FINAL PRODUCT/PROCESS CHANGE NOTIFICATION # 20398Generic Copy

TITLE: Assembly and Test site transfer from Kanto Sanyo Semiconductors Co., Ltd to ON Semiconductor SGC Industries Malaysia Sdn Bhd. (SBN) and Package change from MSOP8 (150mil) to Micro8.

Package size comparison between MSOP8 (150mil) and Micro8

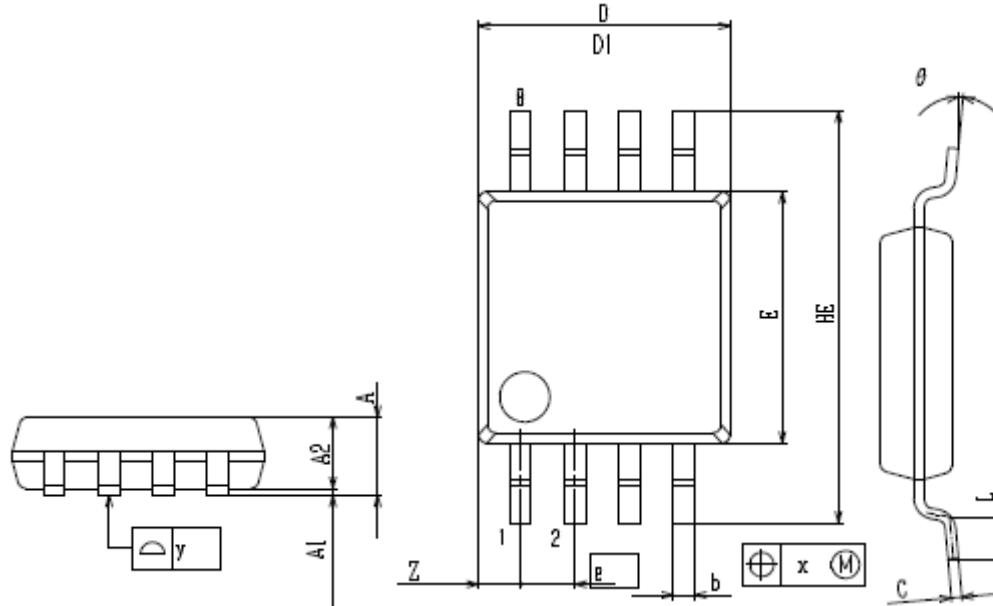
In order to continue supply of applicable products under this condition, the products and the equipments will be transferred to ON Semiconductor SGC Industries Malaysia Sdn Bhd. (SBN). The package will be changed from MSOP8 (150mil) to Micro8 which have been manufactured as standard product in SBN. This package change affects changing for the lead width and lead thickness. The marking name will NOT be changed though the product name will be changed.

The item in red box is changed before and after
